18-601

Professional Services For:
Pumper Apparatus

Addendum #3

19515B Strut Mobile Medical Cabinet Automatic Heating and Cooling

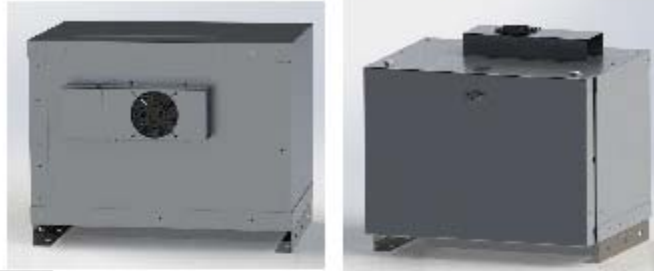
6.103	<u>ADD</u> <u>Images are attached at the end of the addenda.</u>	10	
11.09	<u>DELETE</u> The vehicle will be provided with collision avoidance detection while turning or backing. An audible alarm will sound to alert the driver whenever the apparatus is subject to collision.	10
